Site Accessibility Evaluation

Palmer Lake Recreation Area

Accessibility Evaluation

Inspection Date: 03/10/2020

Finding #4 Continued

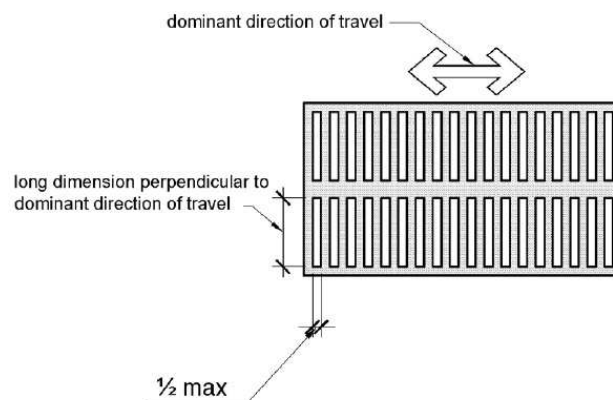
The concrete expansion joint is spaced greater than 1/2 inch.

Concrete expansion joint in front of bathroom is spaced at 1.25 inches

Fill in expansion joint or replace that section of concrete/sidewalk.

Finding #5 Continued

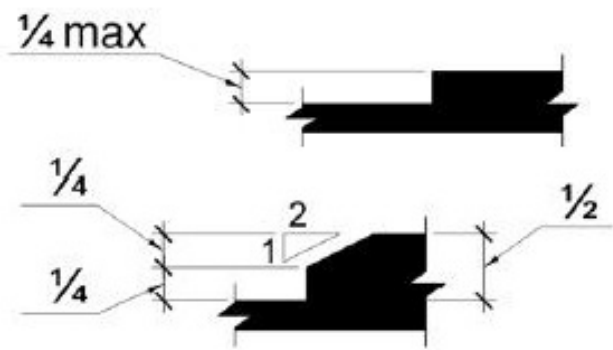
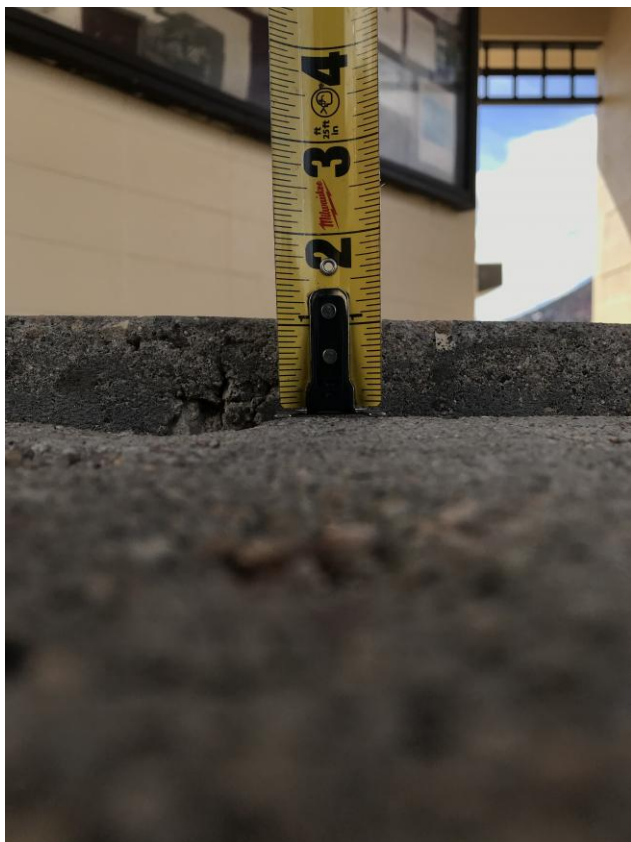
The walkway contains abrupt vertical edges and/or variations over a 1/4 inch.

Walkway contains a 1 inch abrupt vertical change

Shave concrete edge down to 1/4 of an inch, 1/2 inch beveled, or pump/lift, or replace section of concrete/sidewalk.

Finding #6 Continued

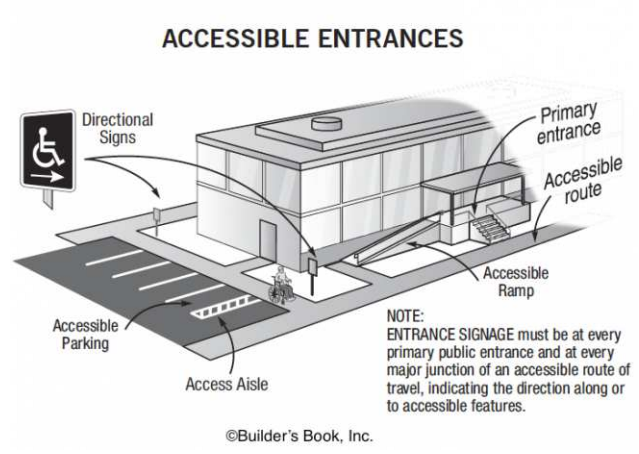
There is no accessible route of travel from the public way.

Gravel route to restroom obstructed by 3 to 4 inches of concrete sidewalk

Construct asphalt or concrete accessible route from parking stall/s to restroom.

Finding #7 Continued

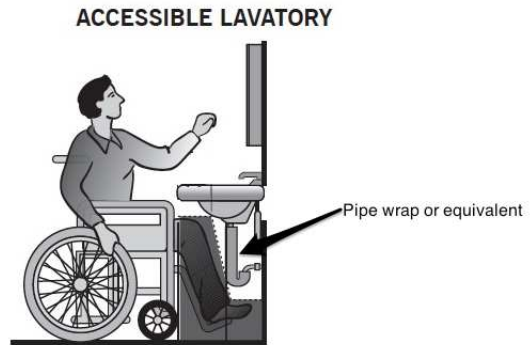
The water and drain pipes under the lavatory are not adequately insulated.

Pipe insulation
missing

Insulate drainpipes underneath lavatory.

Finding #9 Continued

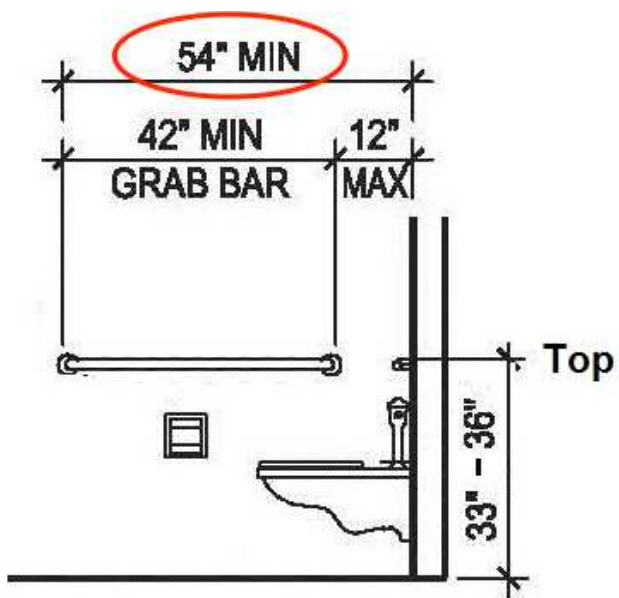
The side grab bar does not extend far enough from the rear wall.

51.25 inches from rear wall

Adjust one side of the grab bar not to exceed 12 inches from rear wall measured to the centerline of the grab bar. The side grab bar must be 42 inches minimum in length and extend at least 54 inches minimum beyond the rear wall.

Finding #10 Continued

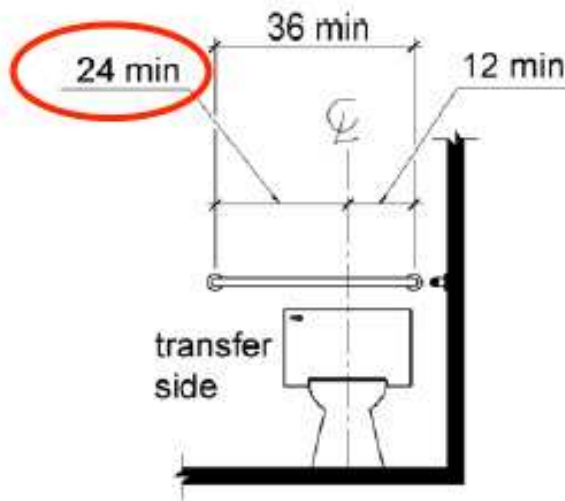
The rear grab bar does not extend adequately past the toilet on the wide side.

19 inches from the side wall

Due to pre-existing conditions, the rear grab bar will not meet current ADA compliance but it's considered compliant due to structural barrier. Once a remodel of the restroom is complete, rear grab bar shall meet or exceed current ADA Standards.

Finding #11 Continued

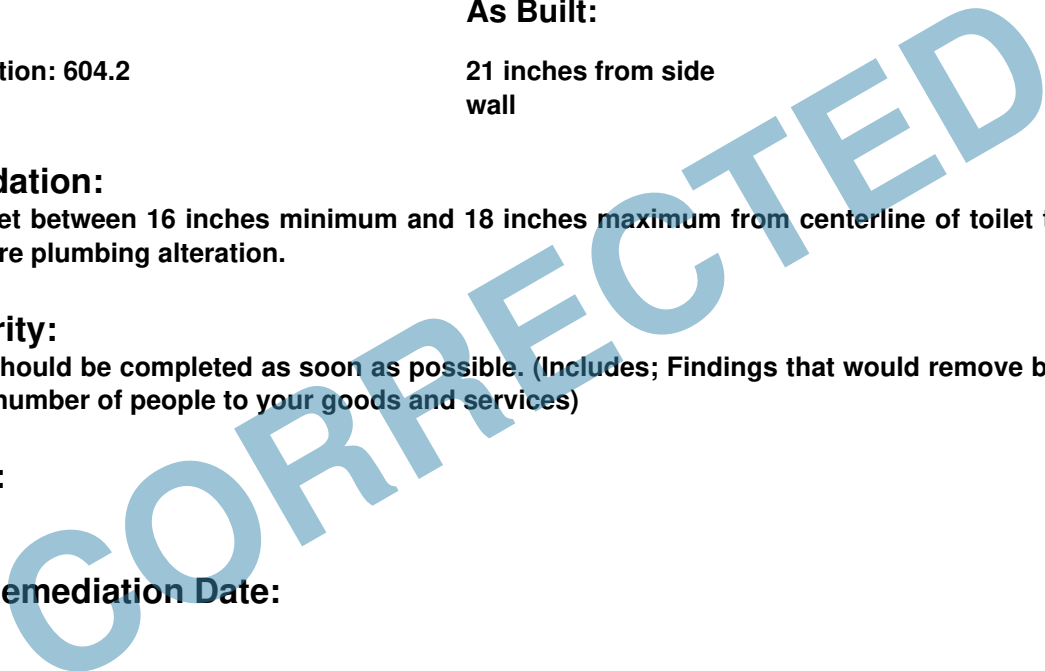
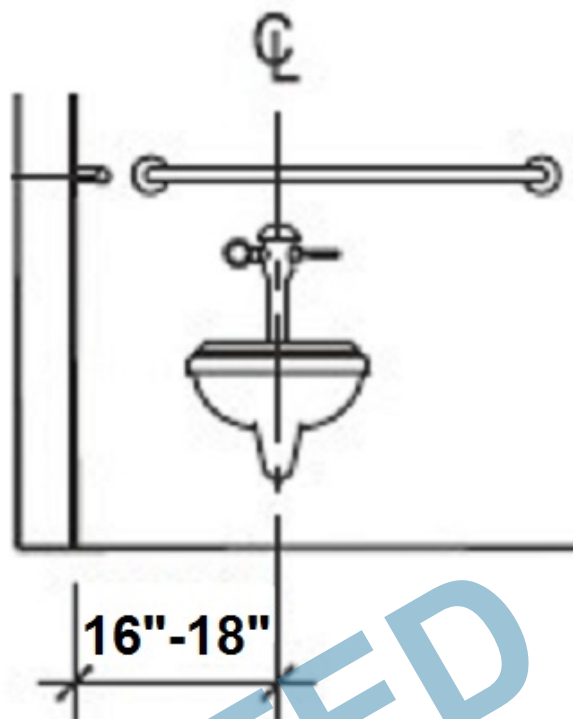
The toilet is not located within the range allowed from the side wall or partition.

21 inches from side wall

Re-position toilet between 16 inches minimum and 18 inches maximum from centerline of toilet to side wall. May require plumbing alteration.

Finding #12 Continued

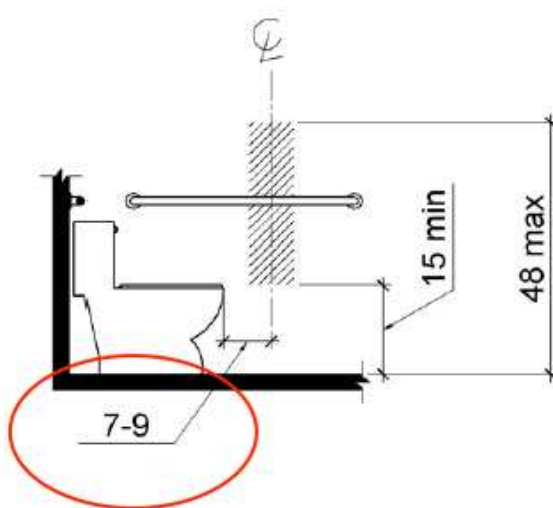
The toilet paper is not installed within the compliant range in front of the toilet.

5 inches from front of toilet

Re-position toilet paper dispenser to be within 7 inches minimum to 9 inches maximum in front of the toilet measured to the centerline of the dispenser.

Finding #13 Continued

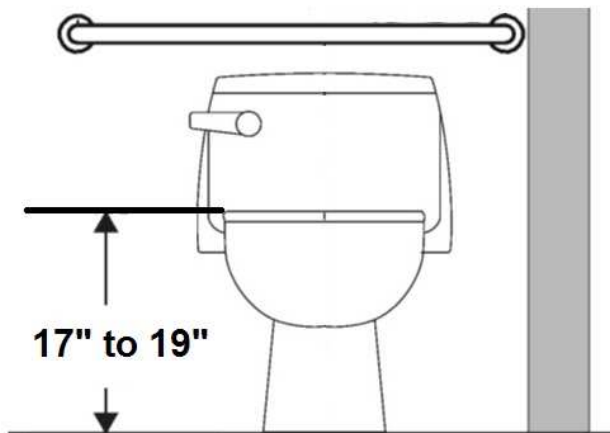
The toilet seat is not located within the range allowed off the floor.

14.75 inches above
finished floor

Adjust toilet height, replace toilet or replace toilet seat with one that will meet the minimum height of 17 inches but no more than maximum height of 19 inches.
